BUILDING REGULATIONS 2010

PLAN NO: 10/13853/BR/1

**EXTENSION TO EXISTING BUNGALOW AT THE ROOKERY, 57A DARTON LANE,
MAPPLEWELL, BARNSLEY, S75 5AL**

**BUILDING REGULATIONS 2000
APPROVED DOCUMENT A - STRUCTURE (2004 EDITION)
REQUIREMENT A2(b) - SUBSIDENCE**

10/13853/BR1

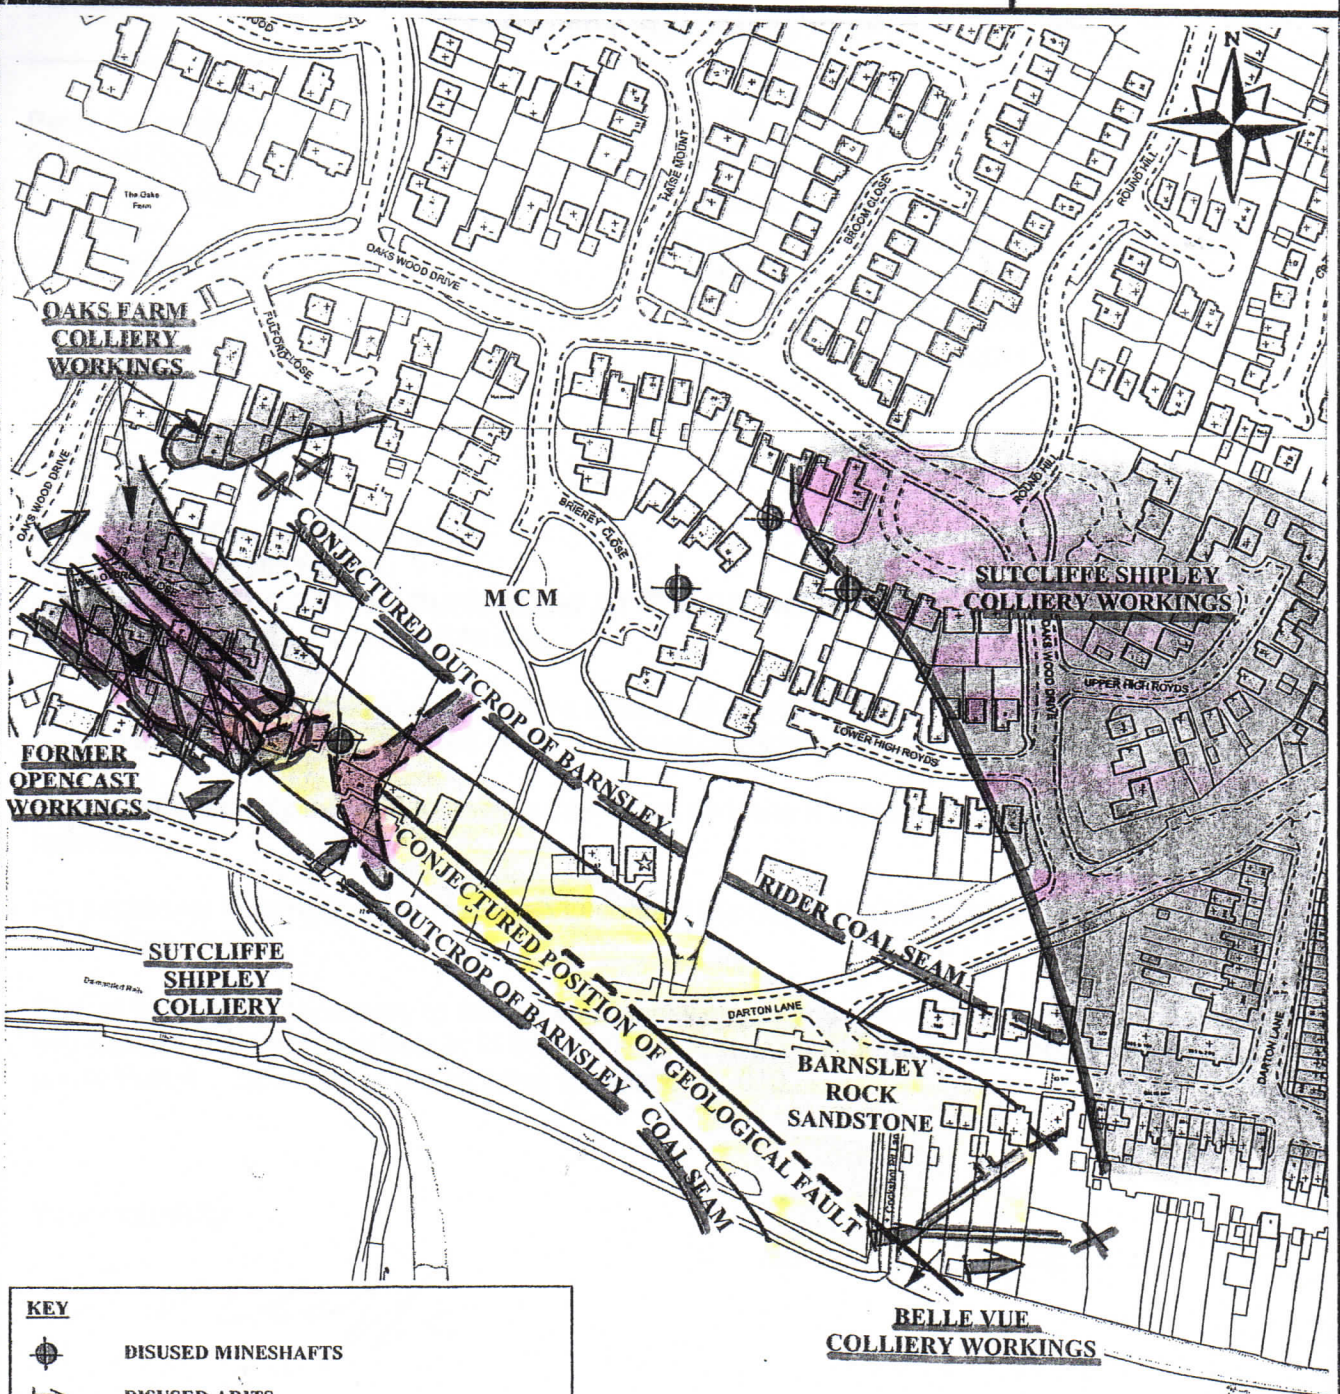
There is insufficient surface information on the site plan for a report to be completed.	A1
This site is fully/partially covered by previous report no.	A2
The conjectured surface position of geological faulting crosses the area as shown on the attached plan.	A3 ✓
Fissure problems may be encountered in the underlying Woolley Edge Rock Sandstone.	A4
The conjectured outcrop of the coal seam marked on the attached plan may be exposed in the foundations.	A5 ✓
The coal seam shown on the plan may be under the proposed development at a shallow depth.	A6 ✓
Shallow mineworkings in the coal seam marked on the attached plan may be present under the site.	A7 ✓
The mine shaft/adit marked on the attached plan is recorded within/adjacent to the site boundary.	A8 ✓
The area marked on the attached plan is shown to be made ground.	A9
The site will be affected by current/future mining.	A10

Where fault/fissure problems are encountered, the foundations should be suitably designed.	B1 ✓
Any coal exposed by building work should be blinded off to prevent spontaneous combustion.	B2 ✓
The necessity for an investigation should be balanced against size and type of proposed development/extension. Boreholes to a depth of 15m would be recommended in this instance. (Prior consultations with the Coal Authority would be required).	B3 ✓
A site investigation should be carried out to check the possible presence of shallow workings/broken ground. Boreholes to a depth of m would be recommended in this instance. (Prior consultations with the Coal Authority would be required).	B4
Ownership of coal mine shafts is vested with the Coal Authority who should be consulted prior to any investigation/measures being undertaken. In any event no building should be sited over the shaft or shaft cap or within an area bounded by a line drawn at 45 degrees back from where the shaft side intersects rockhead.	B5

The foundations may have to be suitably designed to minimise the effect of the current/future mineworkings.	B6
The nature and suitability of any made ground should be investigated.	B7 ✓
Precautions may be required should development be located over the highwall of the former opencast/quarry site due to the potential for differential settlement occurring.	B8 ✓
Although it is not a consideration of the A2(b) requirement all the usual safety precautions and monitoring procedures in respect of fugitive gases (associated with shallow coals, mine entries, made ground or landfill) should be employed during future excavations.	B9 ✓

ACCORDING TO SYMAS RECORDS THE PROPERTY LIES ADJACENT TO MINE ENTRIES, BACKFILLED OPENCAST AND MAY BE ABOVE SHALLOW MINE WORKINGS. NO RECORDS ARE AVAILABLE WITH REGARD TO ORIGINAL FOUNDATION DESIGN AND ANY PRIOR SITE INVESTIGATION. IT IS NOT KNOWN IF ANY GAS PRECAUTION MEASURES ARE INCORPORATED INTO THE EXISTING PROPERTY.
